FLORIDA POWER & LIGHT COMPANY

ST. LUCIE PLANT UNIT NO. 1

AMENDMENT TO FACILITY OPERATING LICENSE

Amendment No. 32
License No. DPR-67

FIGURE 2.2-2
Local Power Density-High Trip Setpoint Part 2 (QR₂ Versus Y₁)

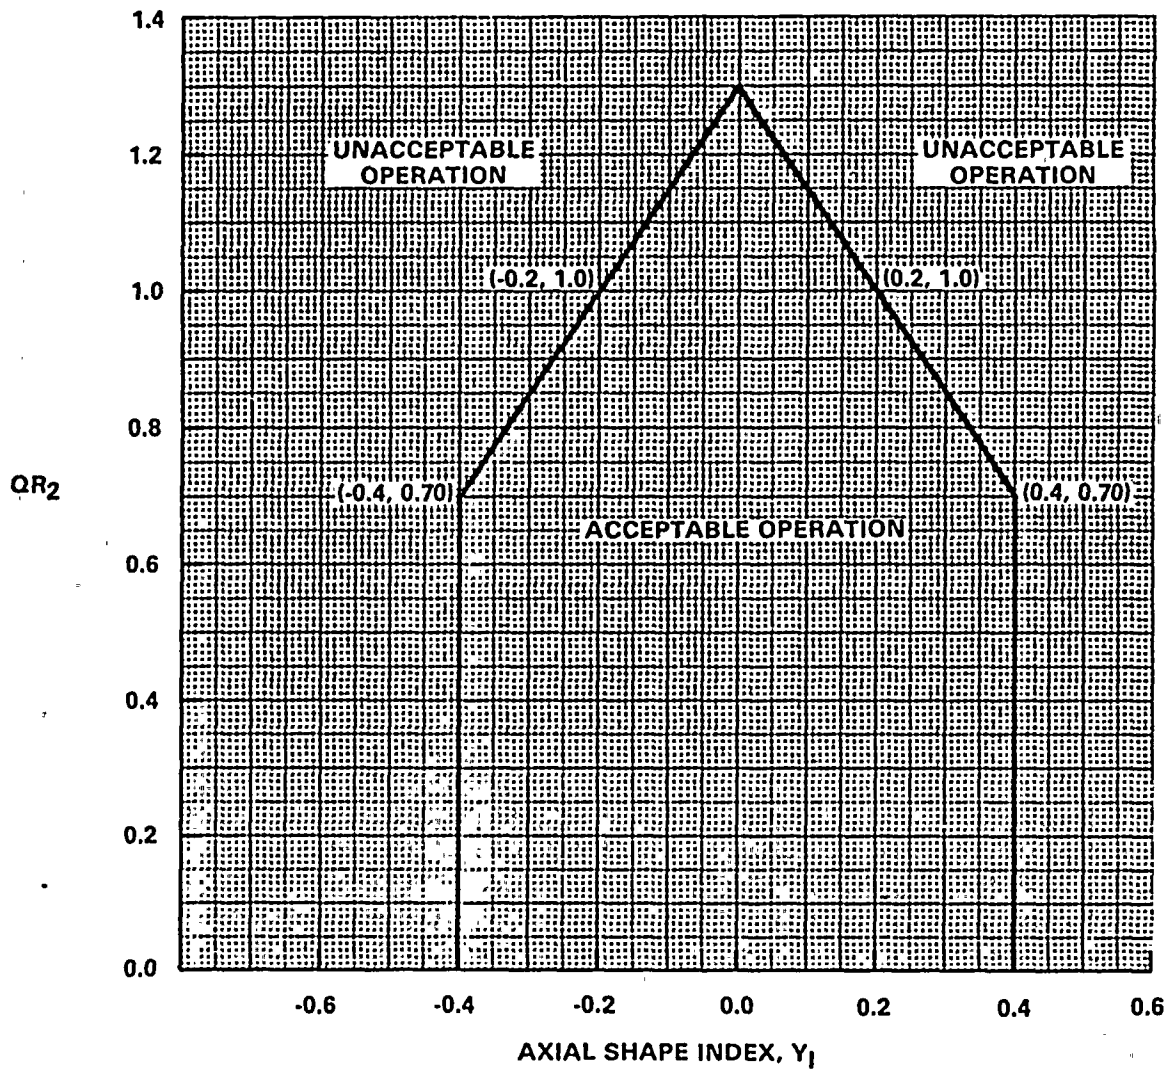
7. Steam Generator Water Level -Low	$\geq 37.0\%$ Water Level - each steam generator	$\geq 37.0\%$ Water Level - each steam generator
8. Local Power Density - High (3)	Trip setpoint adjusted to not exceed the limit lines of Figures 2.2-1 and 2.2-2	Trip set point adjusted to not exceed the limit lines of Figures 2.2-1 and 2.2-2.

FIGURE 3.2-1 Allowable Peak Linear Heat Rate vs Burnup.

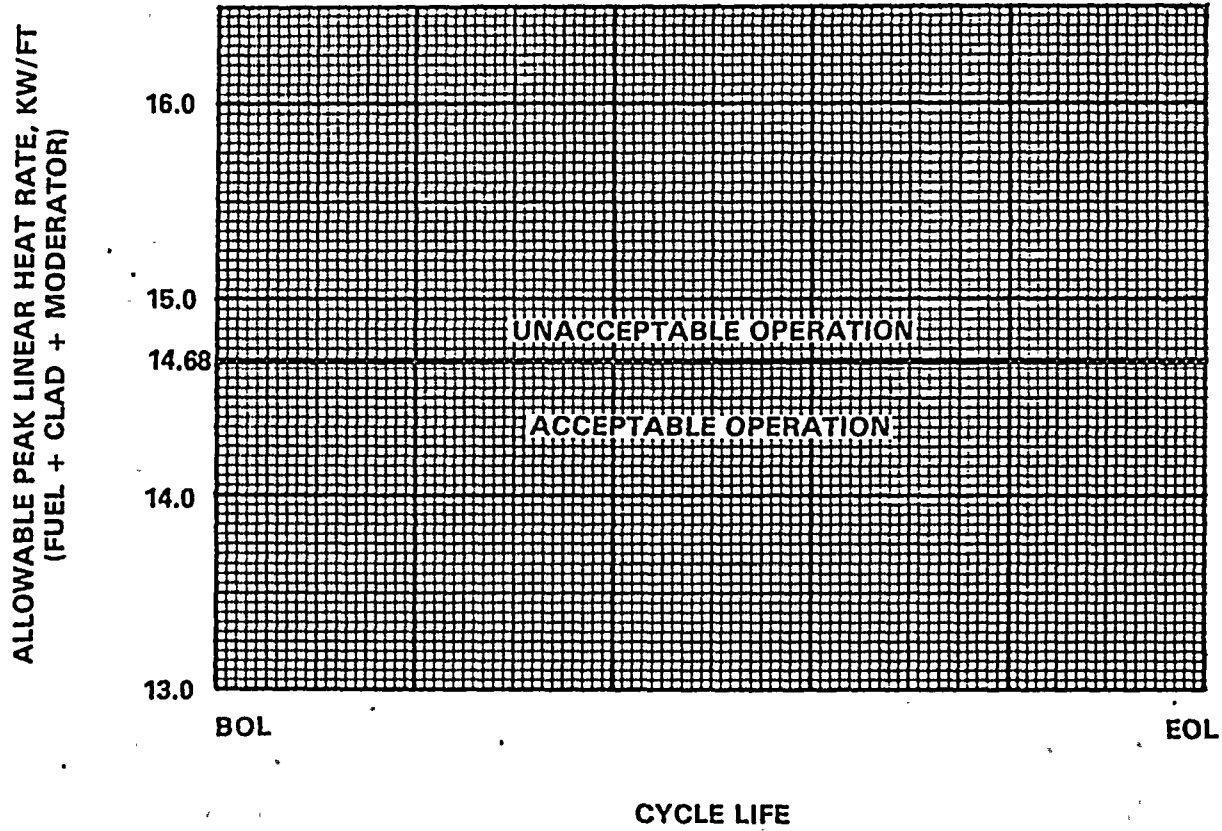
3.2.1 The linear heat rate shall not exceed the limits shown on Figure 3.2-1.

FIGURE 3.2-2
 AXIAL SHAPE INDEX vs Fraction of Maximum Allowable Power Level Per Specification 4.2.1.3

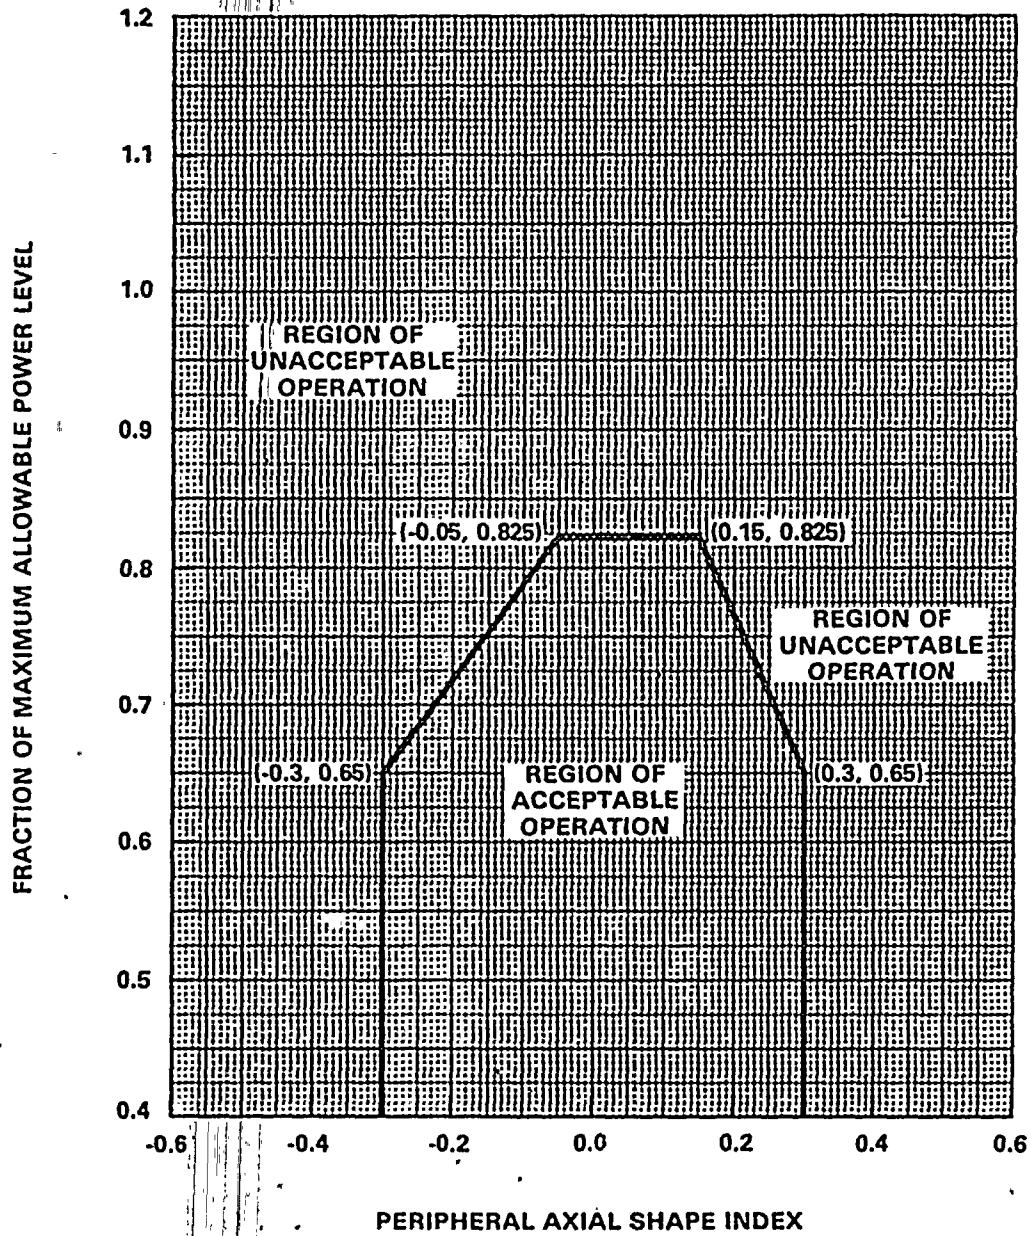
- a. Verifying at least once per 12 hours that the full length CEAs are withdrawn to and maintained at or beyond the Long Term Steady State Insertion Limit of Specification 3.1.3.6.
- b. Verifying at least once per 31 days that the AXIAL SHAPE INDEX alarm setpoints are adjusted to within the limits shown on Figure 3.2-2.

- c. Verifying that the AXIAL SHAPE INDEX is maintained within the allowable limits of Figure 3.2-2, where 100 percent of maximum allowable power represents the maximum THERMAL POWER allowed by the following expression:

FIGURE 3.2-3
 Allowable Combinations Of Thermal Power And F_r^T, F_{xy}^T

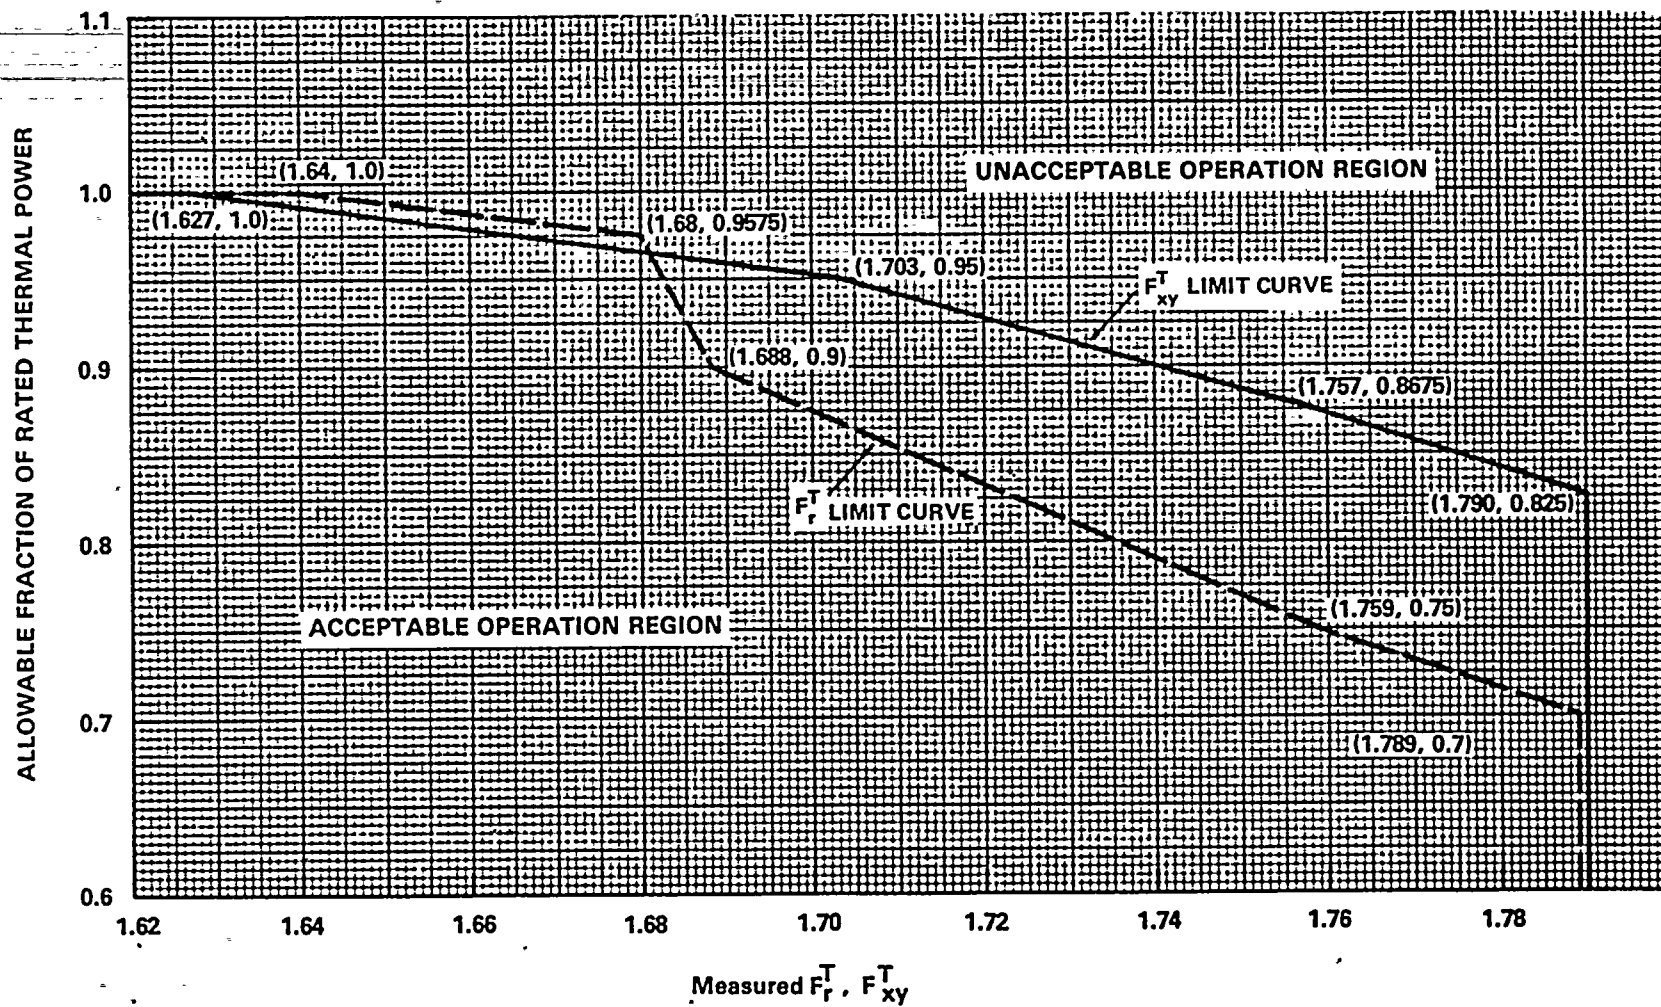
- a. Reduce THERMAL POWER to bring the combination of THERMAL POWER and F_{xy}^T to within the limits of Figure 3.2-3 and withdraw the full length CEAs to or beyond the Long Term Steady State Insertion Limits of Specification 3.1.3.6; or
- b. Be in HOT STANDBY.

- a. Be in at least HOT STANDBY, or
- b. Reduce THERMAL POWER to bring the combination of THERMAL POWER and F_r^T to within the limits of Figure 3.2-3 and withdraw the full length CEAs to or beyond the Long Term Steady State Insertion Limits of Specification 3.1.3.6. The THERMAL POWER limit determined from Figure 3.2-3 shall then be used to establish a revised upper THERMAL POWER level limit on Figure 3.2-4 (truncate Figure 3.2-4 at the allowable fraction of RATED THERMAL POWER determined by Figure 3.2-3) and subsequent operation shall be maintained within the reduced acceptable operation region of Figure 3.2-4.
